ANVO22GQ Connector

ANV022GQ

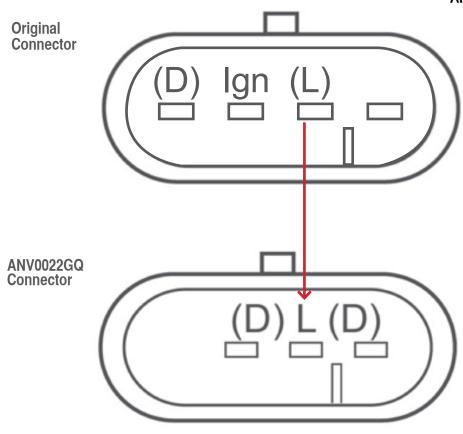
The Connector on the original alternator that JAS ANV022GQ replaces has a different pin configuration to the ANV022GQ. The physical plug is the same, and the "L" or warning light terminal is in the same position.

ANV022GQ only requires the L terminal to operate so there are no changes required to use the OE vehicle connector.
